**dsPIC30F6011/6012/6013/6014**

**dsPIC30F6011/6012/6013/6014 Family  
Silicon Errata and Data Sheet Clarification**

The dsPIC30F6011/6012/6013/6014 family devices that you have received conform functionally to the current Device Data Sheet (DS70117F), except for the anomalies described in this document.

FIGURE 1: DCI SLAVE WORK AROUND

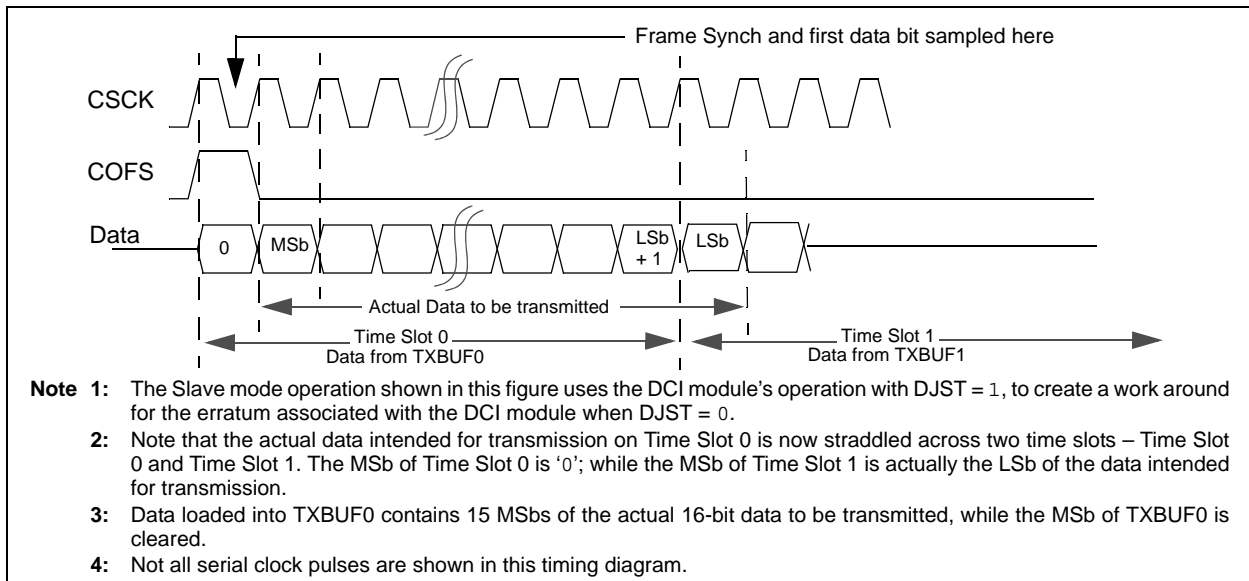
The Data Converter Interface (DCI) module does not function correctly in Slave mode when the following conditions are true:

- The DCI module is configured to transmit/receive one serial clock (bit clock) after the frame synchronization pulse, DJST (DCICON1<5>) = 0.
- The frame length chosen is longer than 1 word, COFSG<3:0> (DCICON2<8:5>) > '0000'.

The following work around may be applied to enable DCI communication in Slave mode when it is configured to transmit one serial clock after the frame synchronization pulse is received in a multi-word frame:

1. Set the DJST bit to '1'.
2. Enable an additional time slot immediately following each time slot intended for communication.
3. Enable an additional transmit/receive buffer word (modify COFSG bits) or an additional bit per word (modify WS) for each time slot intended for communication.
4. Shift the data word by 1-bit to the right and load the transmit buffer word(s), such that the Least Significant bit of the original data word to be transmitted is loaded into the additionally enabled bit of the Transmit Buffer register, TXBUF<sub>n</sub>, or the Most Significant bit (MSb) of the additionally enabled transmit buffer, TXBUF<sub>n+1</sub>.

Assume, the application needs the DCI module to act as a Slave transmitting 1 serial clock after the frame synchronization pulse is received. Further, assume that the application needs to transmit 16-bit data word on Time Slot 0 and the communication is over a 256\*Fs channel. In order to reduce interrupt frequency, we enable all 4 transmit buffers. The DCI module SFRs should be initialized as follows before being enabled:

- DCICON1 = 0x0720, DCICON2 = 0x0DEF  
DCICON3 = 0x0000,  
TSCON = RSCON = 0x0003

An example of loading the DCI transmit buffers for the configuration above is shown in Example 11. A timing diagram in Figure 1 illustrates the various signals for this example. A similar rule may be applied to reading the received data from the RXBUF<sub>n</sub> SFRs.
